SF-21-049

2021 Financial Assurance Estimate Form
(with pre-plat construction)

PROJECT INFORMATION		
Project Name FOREST LAKES FILING 7	Date 11/22/21	PCD File No.

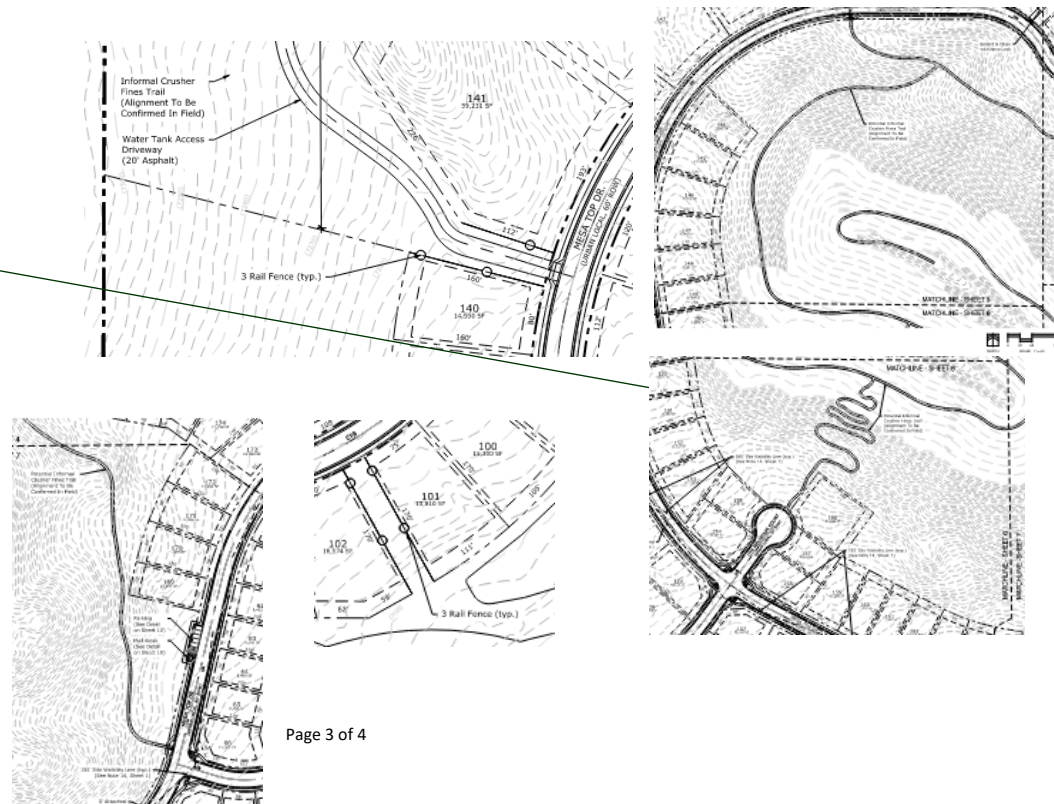
Please crosscheck recorded PUD, and add the cost for the trails, & fence materials... (Please note some of the trails are not feasible due to the rattlesnake nesting-
